PREPARED FOR THE PLAN COMMISSION

**Project Address:** 2583 University Avenue (5<sup>th</sup> Aldermanic District, Alder Bidar-Sielaff)  
**Application Type:** Conditional Use  
**Legistar File ID #:** [36814](#)  
**Prepared By:** Heather Stouder, AICP, Planning Division  
Report Includes Comments from other City Agencies, as noted

**Requested Action:** Approval of a conditional use for construction of a 27-unit multi-family residential building over 10,000 square feet in size and over 40 feet in height in the Traditional Shopping Street (TSS) District.

**C-1.1**

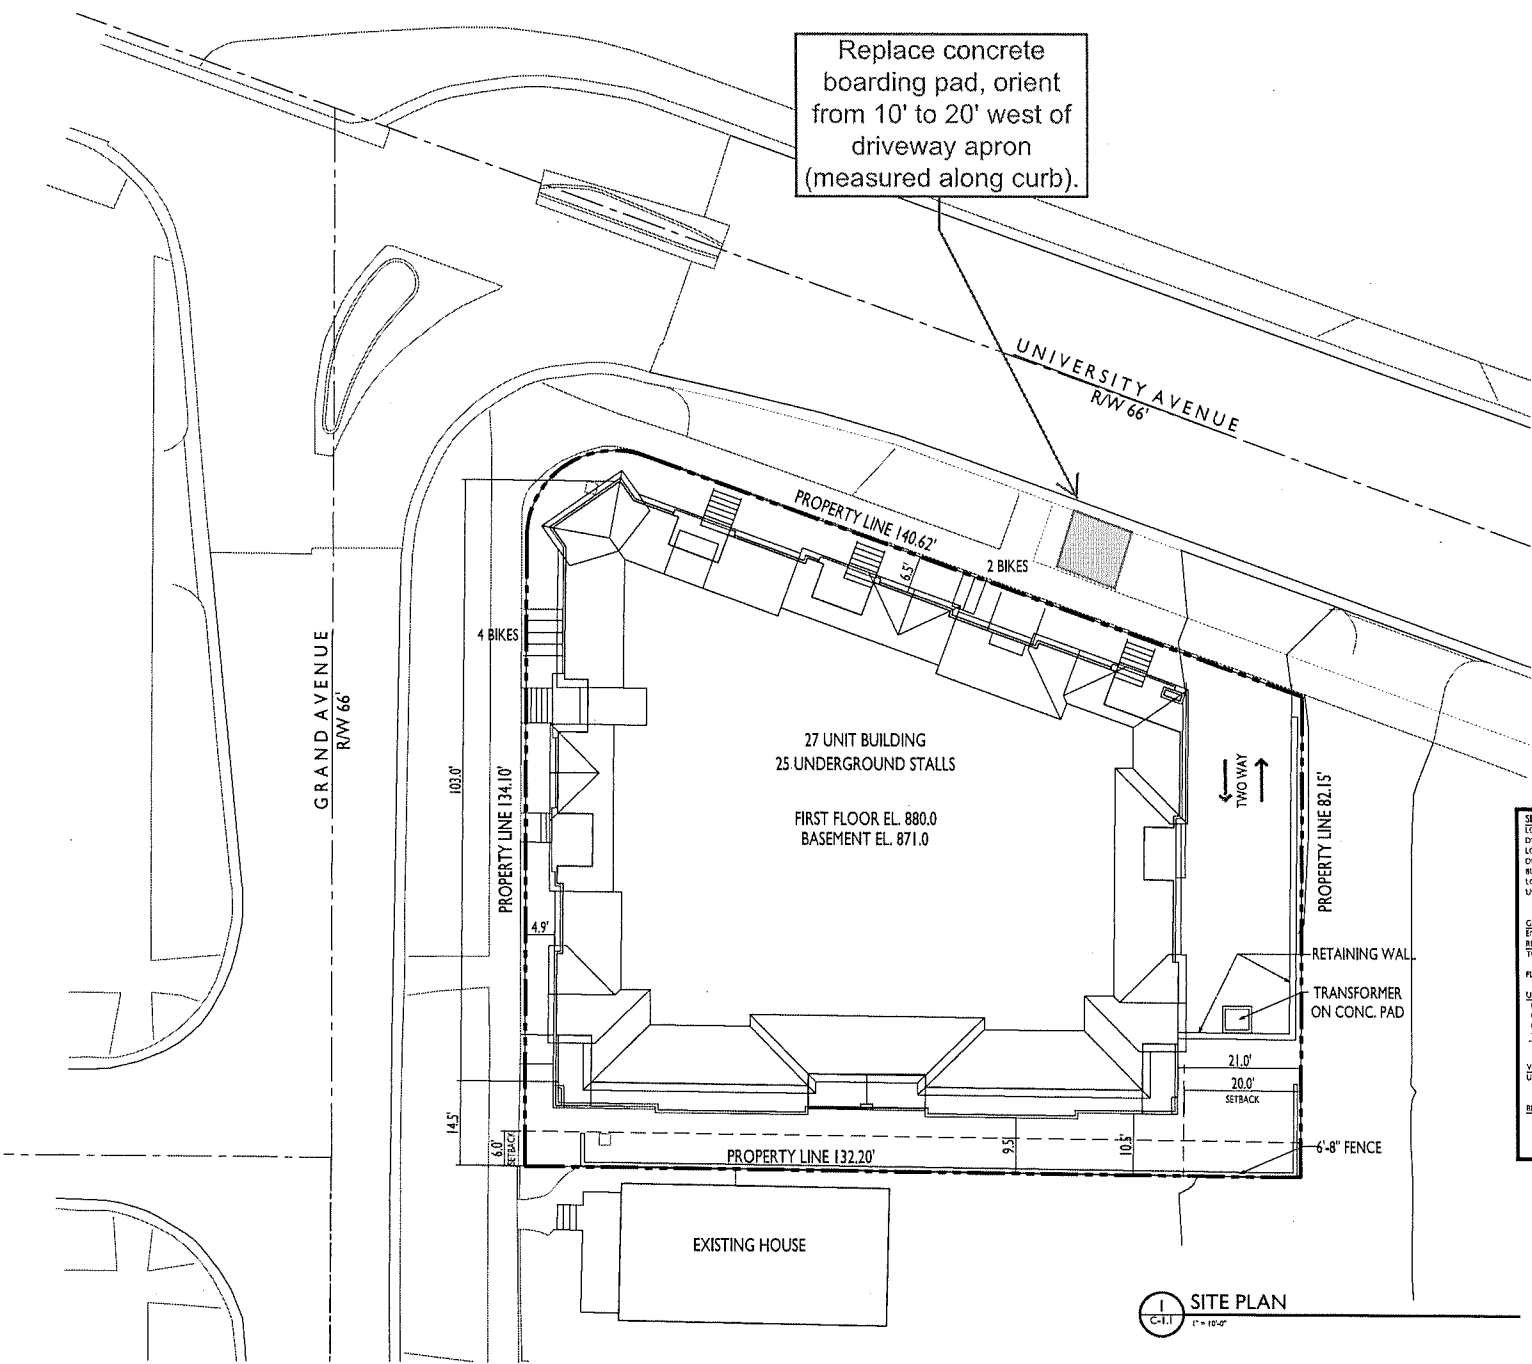
45. In coordination with public works improvements, the applicant shall replace the concrete passenger boarding pad at the existing Metro bus stop on the south side of University Avenue, east of Grand Avenue (#2433). The concrete pad shall occupy the full distance of the terrace, measure a minimum of 10 feet in width parallel to the street, and lie flush between the sidewalk and the top of curb. The replacement concrete pad shall be oriented to span from ten feet to twenty feet west of the new (narrowed) driveway apron.

Replace concrete boarding pad, orient from 10' to 20' west of driveway apron (measured along curb).
